8802-3/802.3 REVISION REQUEST

REQUESTED REVISION:  
STANDARD: IEEE Std 802.3ab-1999  
CLAUSE NUMBER: 40C.2.1 and Figure 40C-2  
CLAUSE TITLE: Auto-Negotiation Transmit state machine add-on  
for 1000BASE-T

Figure 40C-2 as modified by Revision requests 1042 to 1049 - Changes annotated

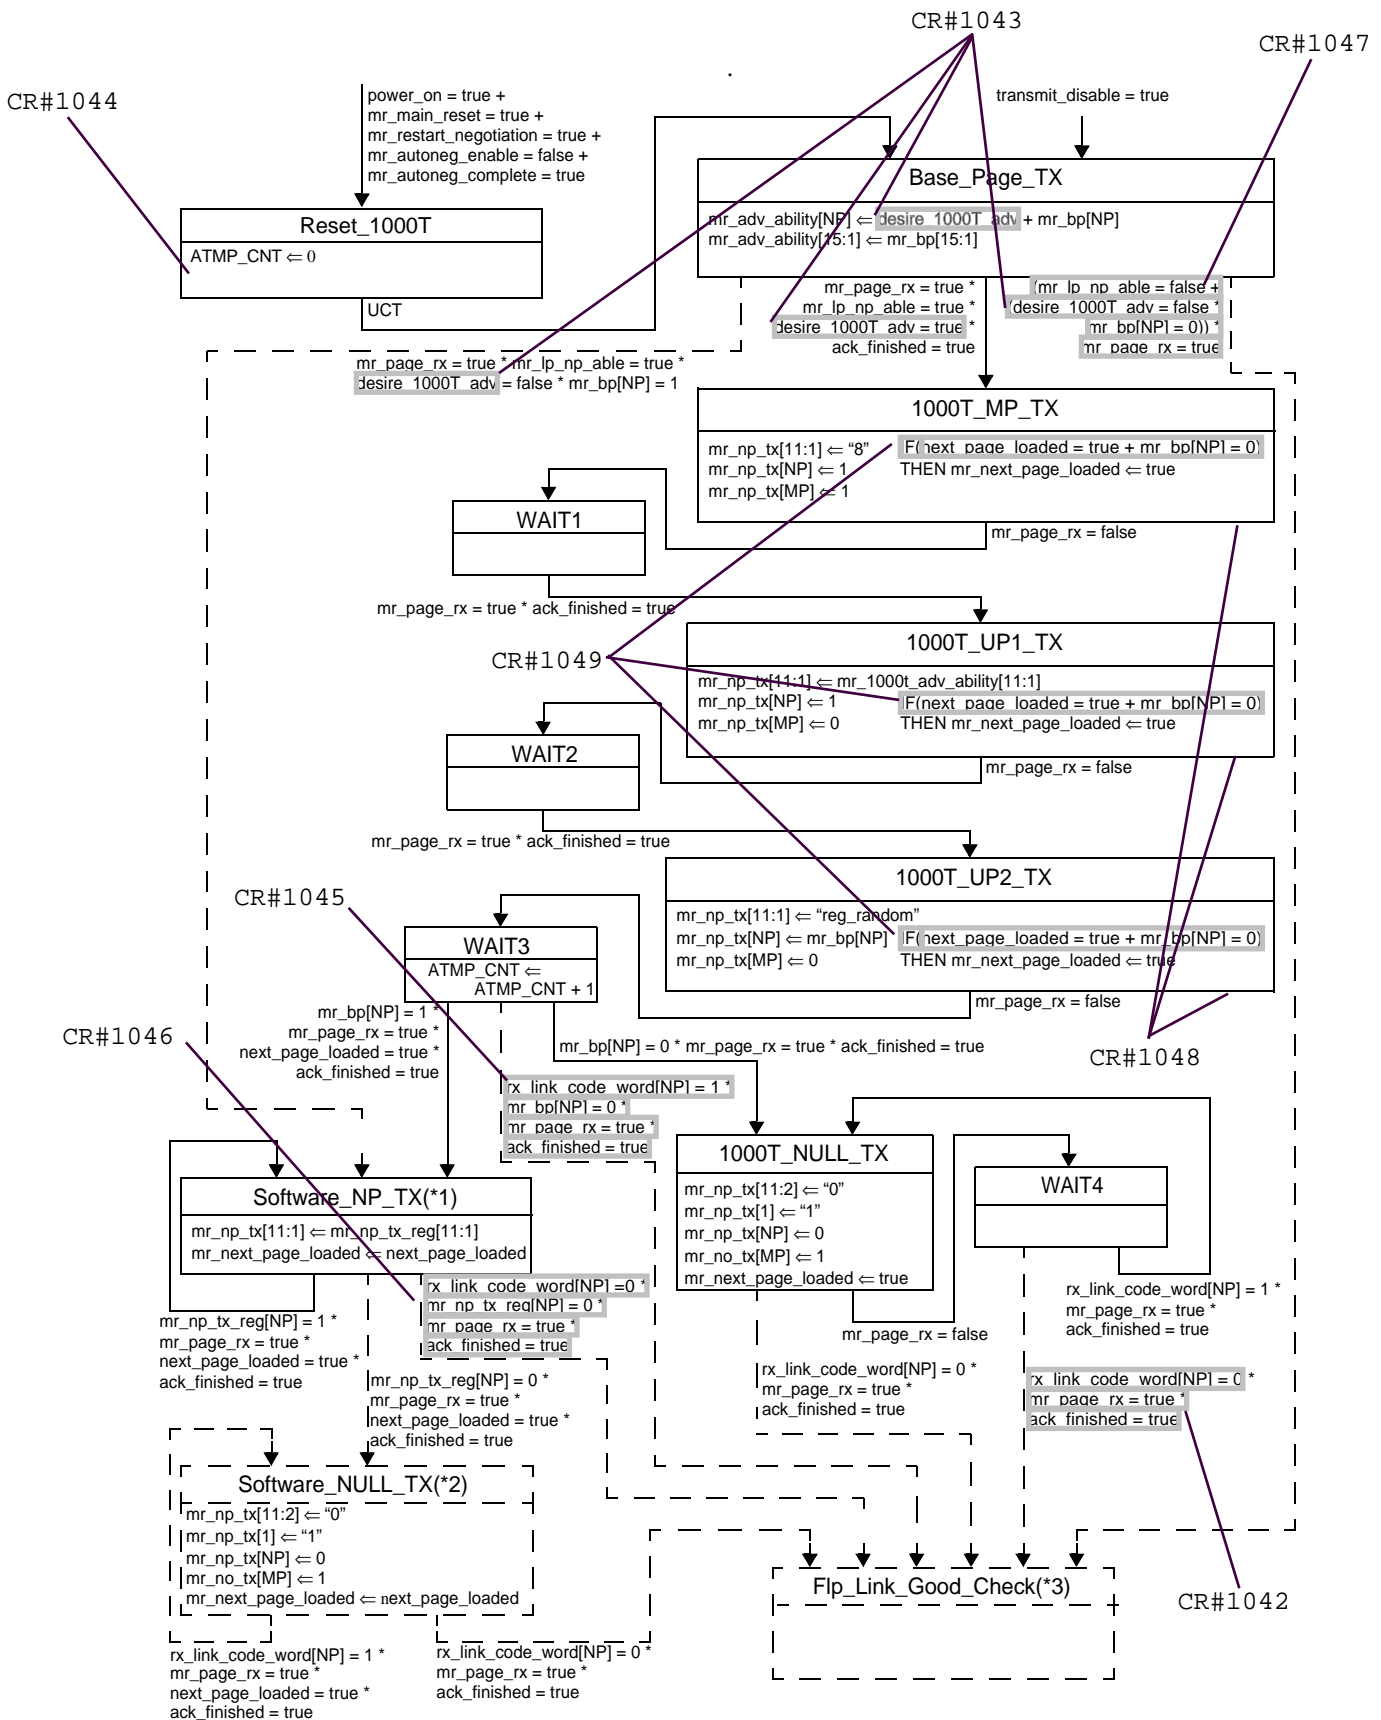
Remove mr\_np\_able <= 1 from the Reset\_1000T state in Figure 40C-2.

In the Reset\_1000T state setting mr\_np\_able to one would make all devices Next Page able. There will still be existing devices that do not support Next Page.
